GULF STATES UTILITIES COMPANY

March 15, 1985
RBC-20430
File No. G9.5, G9.8.7

River Bend Station - Unit 1
Docket No. 50-458

Enclosed for your review are revisions to the River Bend Station (RBS) Final Safety Analysis Report (FSAR). These revisions reflect a change in the calculations for the ultimate heat sink maximum temperature due to revisions in plant equipment operation. These revisions to FSAR Section 9.2.5 will be included in a future amendment.

FIGURE 9.2-16
 TOTAL INTEGRATED RHR
 DISCHARGE HEAT INPUT
 TO SSW FOLLOWING A LOCA
 RBS F S A R

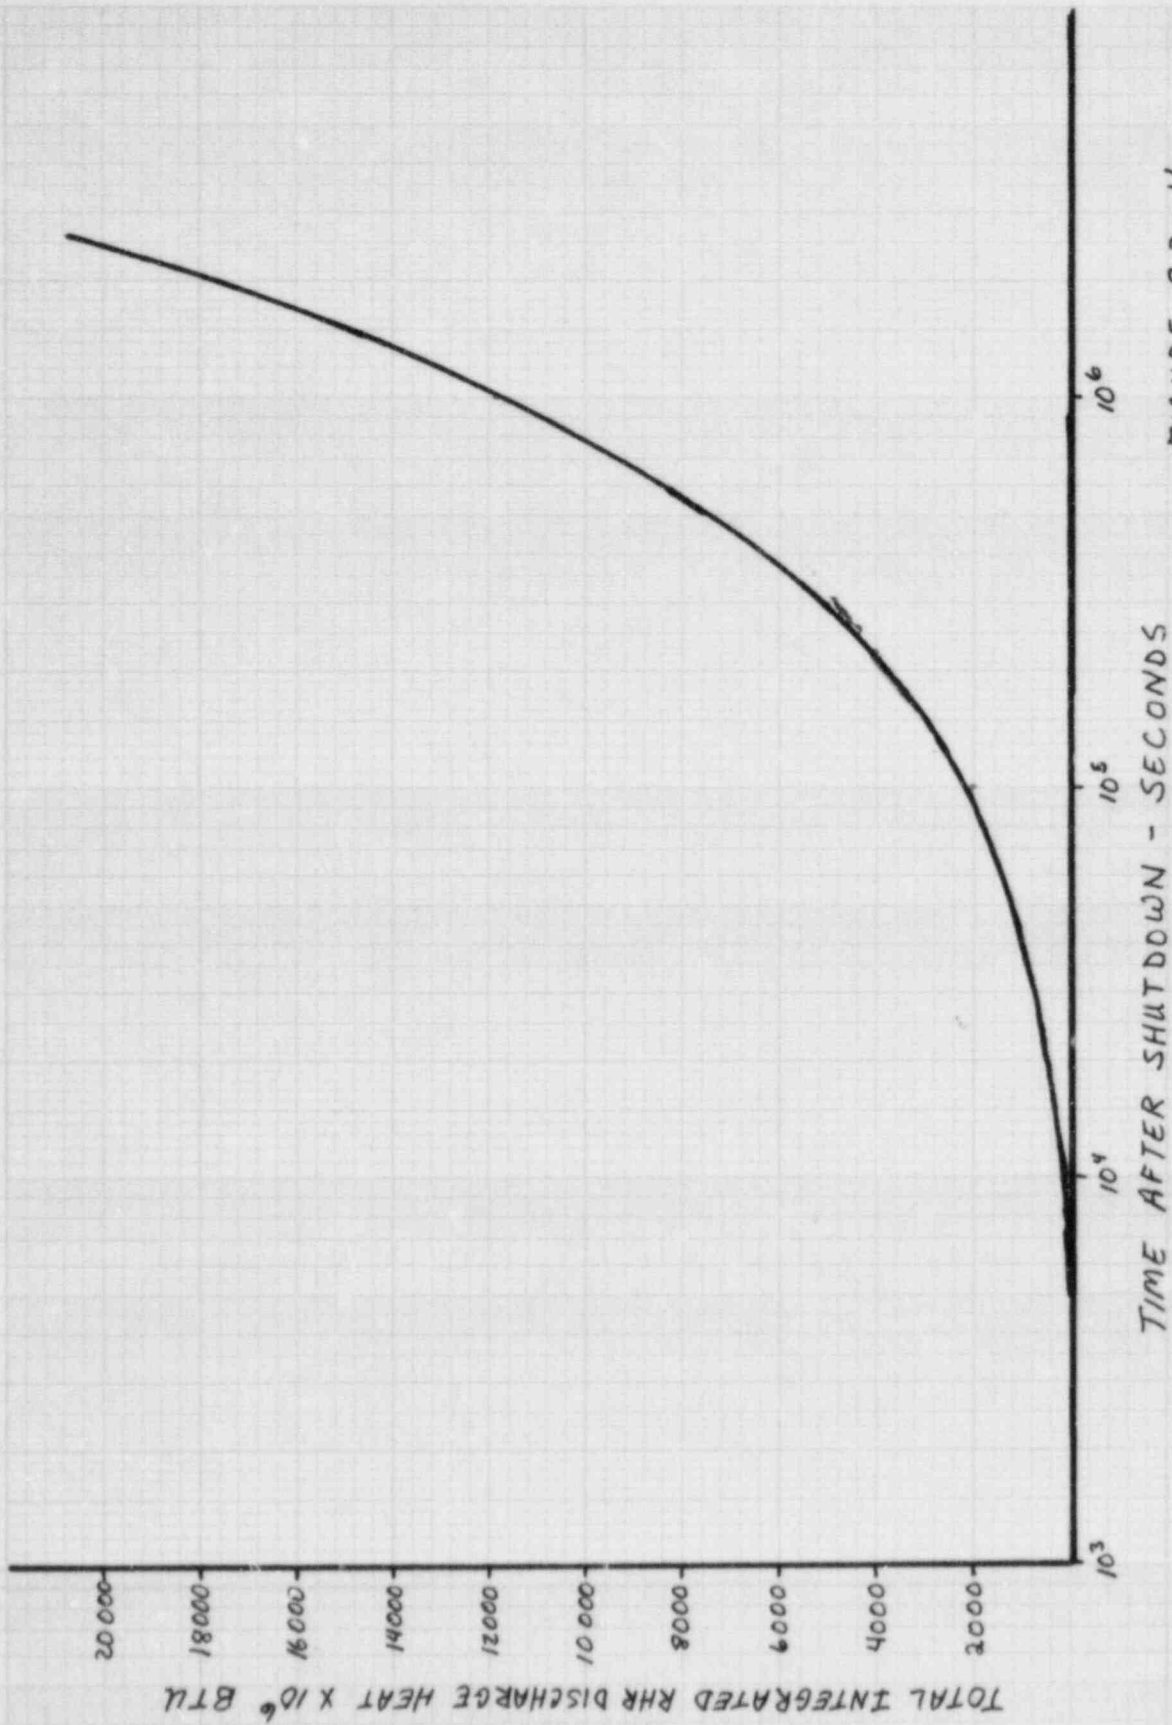
Total integrated decay heat input to standby service water from core decay heat due to fission products and heavy elements is given in Table 9.2-5 and shown on Fig. 9.2-16.

FIGURE 9.2-17
 PLANT AUXILIARIES
 HEAT INPUT TO SSW
 FOLLOWING A LOCA
 RB S F S A R

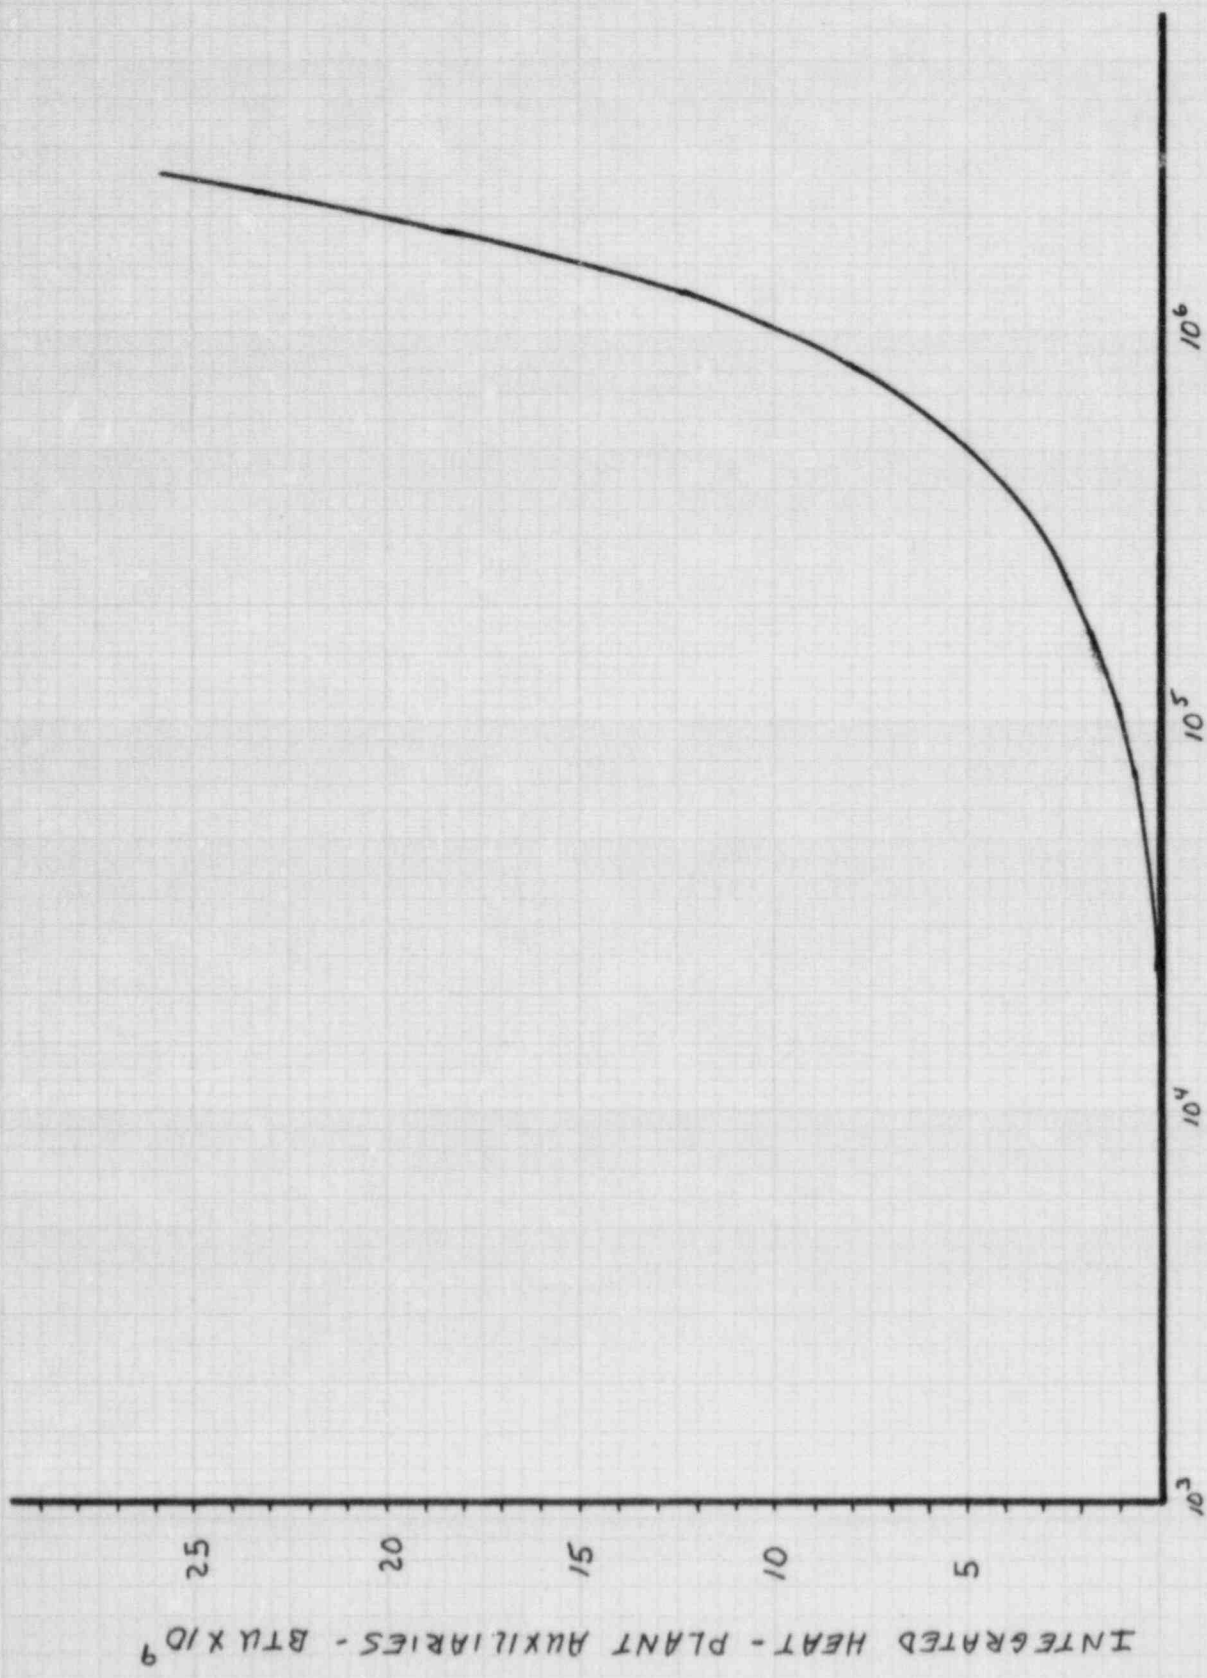
The integrated heat rejection from the plant auxiliaries is given in Table 9.2-6. The plant auxiliaries heat input to the standby service water system is presented in Table 9.2-7 and shown on Fig. 9.2-17.

FIGURE 9.2-18
CONTAINMENT UNIT
COOLER HEAT INPUT TO
SSW FOLLOWING A LOCA

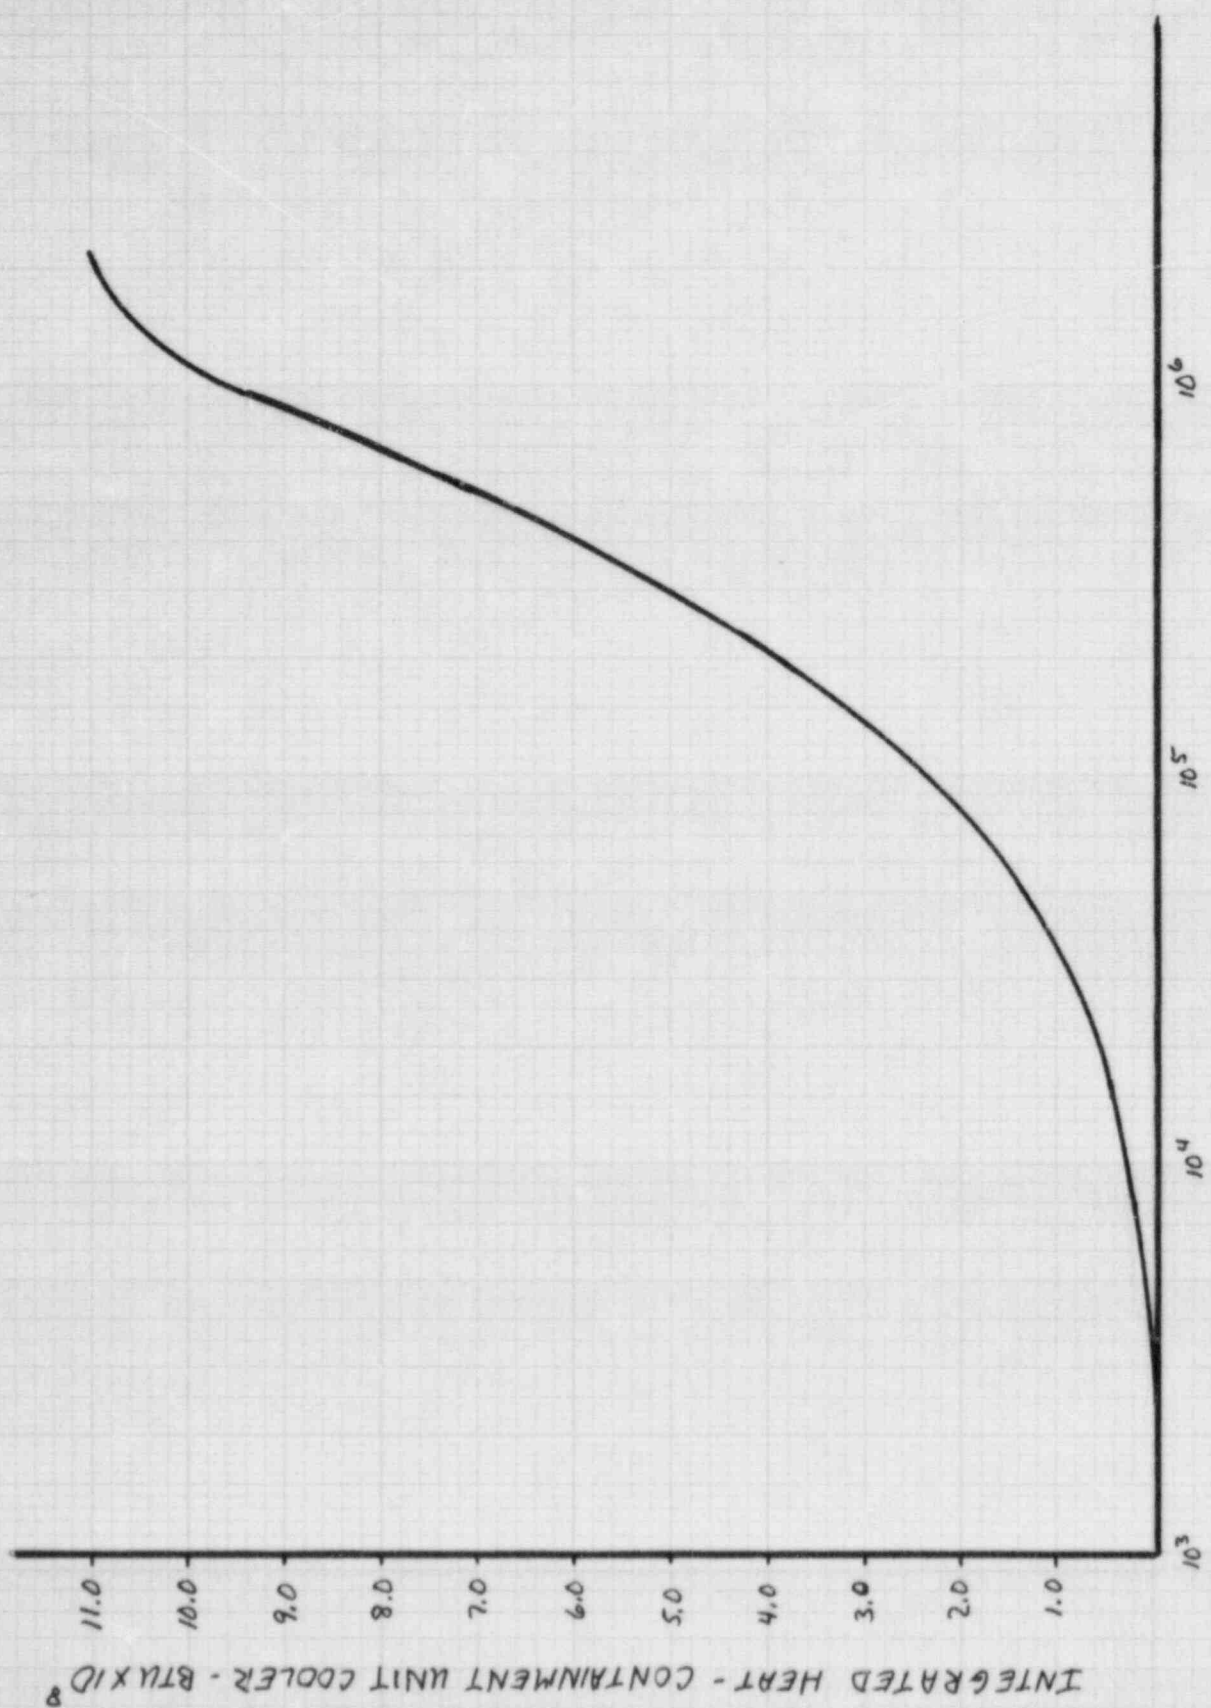
The heat rejection rate due to change in sensible heat is given in Table 9.2-8 and shown on Fig. 9.2-18.
